Case: Wood Duck 2024-00337

I would like to provide the following comments on the Sound Study by Stantec.

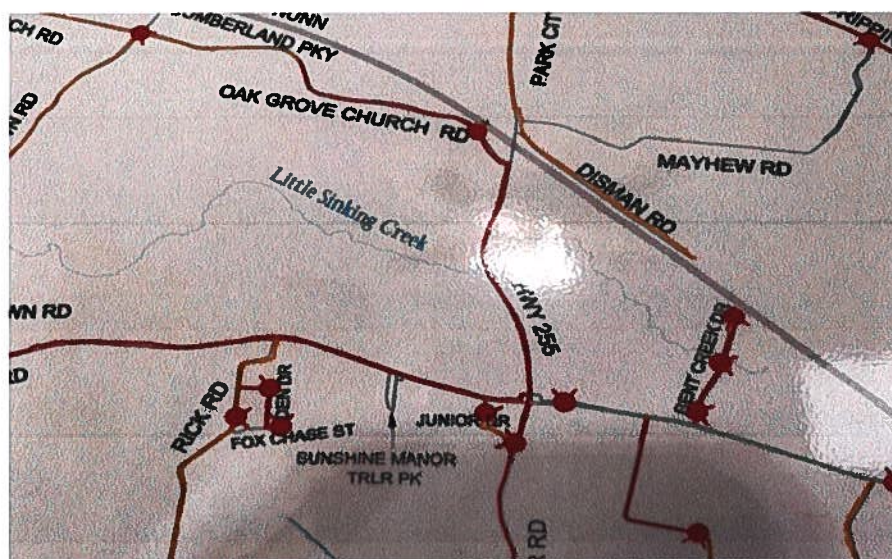
The Stantec study for glare used latitude and longitude quadrants while the Stantec study for sound used "sound receptors" which are numbered structures along the roads and the maps do not identify the roads, so one cannot determine addresses. **Stantec should combine their systems to allow easy readability by the public.**

Kirkland used last names and parcel numbers, which can't be related to the sound and glare studies, so there is no way to cross reference.

Perhaps designed to confuse?

Stantec needs to use parcels and addresses so one can easily understand the impact of the project and how it will be designed.
